UNITED STATES
NUCLEAR REGULATORY COMMISSION
WASHINGTON, D.C. 20555-0001

SUBJECT: THREE MILE ISLAND NUCLEAR STATION, UNIT 1 – SAFETY EVALUATION REGARDING IMPLEMENTATION OF MITIGATING STRATEGIES AND RELIABLE SPENT FUEL POOL INSTRUMENTATION RELATED TO ORDERS EA-12-049 AND EA-12-051 (CAC NOS. MF0803, AND MF0866)

Enclosure:
Safety Evaluation

Figure 1 - "TMI SFP Levels of Monitoring"

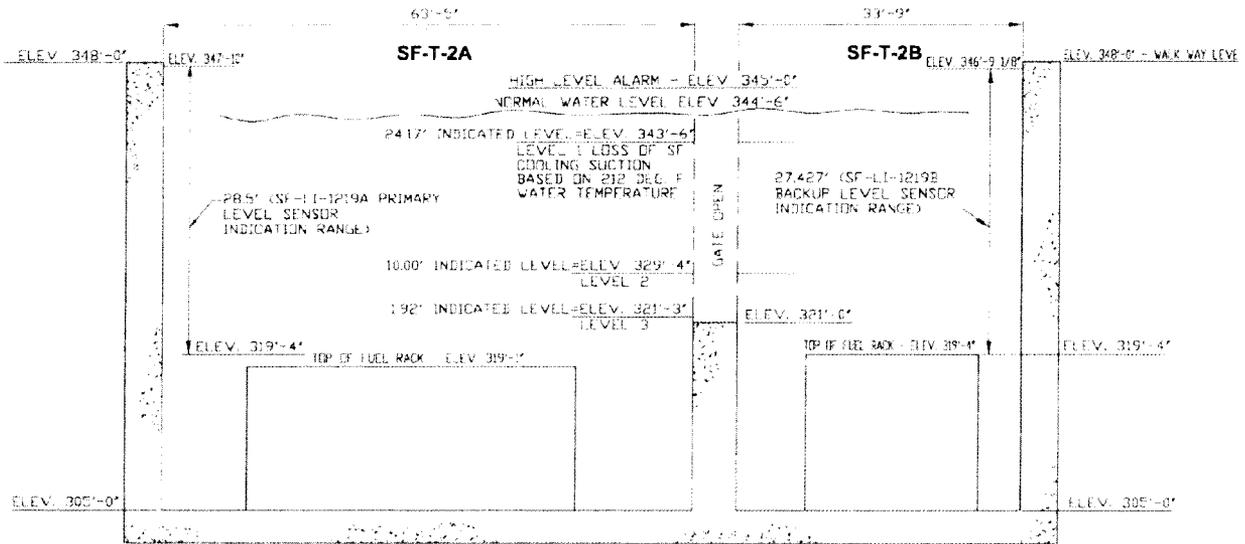
The NRC staff's assessment of the licensee selection of the SFP levels of monitoring is as follows: per NEI 12-02, Section 2.3.1, Level 1 will be the higher of two points. The first point is the water level at which suction loss occurs due to uncovering of the spent fuel cooling inlet pipe. This was identified by TMI as elevation 341ft. 11in. The second point is the water level at which loss of spent fuel cooling pump NPSH occurs under saturated conditions. This was identified by TMI as below elevation 343ft 6in. The Three Mile Island designated Level 1 (343ft. 6in.) is the HIGHER of the above two points and therefore consistent with NEI 12-02. Level 2 was identified as elevation 329ft. 4in. This level is consistent with the first of the two NEI 12-02 options for Level 2, which is 10 feet (+/- 1 ft.) above the highest point of any fuel rack seated in the SFP. Level 3 is consistent with NEI 12-02 Level 3, which is above the highest point of any fuel rack seated in the SFP.

In its letter dated January 20, 2016 [Reference 31], the licensee provided a sketch depicting the final SFP levels of monitoring and the instrument measurement ranges (Figure 1 of this evaluation). In this figure, the measurement range for the primary channel is from 347ft. 10in. to 319ft. 4in. plant elevations. The measurement range for the backup channel is from 346ft. 9 1/8in. to 319ft. 4in. plant elevations. The NRC staff noted that the instrument measurement ranges will cover Levels 1, 2, and 3, as described in Section 4.1 above. However, the staff had concerns regarding the possible effects on the reliability of the SFP level instrumentation when the gate is closed. In its letter dated August 28, 2015 [Reference 32], the licensee provided a response to the staff's concern, in which it stated that complete redundant monitoring of the SFPs will not be available when the gate between SFP "A" and "B" is installed. This gate has not been installed for more than 37 years. It was installed to re-rack the SFP "B" at that time. There is no intention to install the gate in the future. If the gate is installed, there is an existing Procedure 1507-2, "Fuel Handling Building Crane Operation," to install and remove the gate. According to the licensee, Procedure 1507-2 will be revised to establish administrative guidance/controls to follow the NEI 12-02, Section 4.3 guidance for the 90-day out of service criterion. Furthermore, during the onsite audit, the licensee stated that Procedure CC-TM-118-1001, "TMI Diverse and Flexible Coping Strategy (FLEX) Program Document," will be revised to include SFP instrumentation (SFPI) channel unavailability actions. The staff found that the licensee adequately addressed the staff's concerns with regard to the effects on the reliability of the SFP level instrumentation caused by the gate installation.
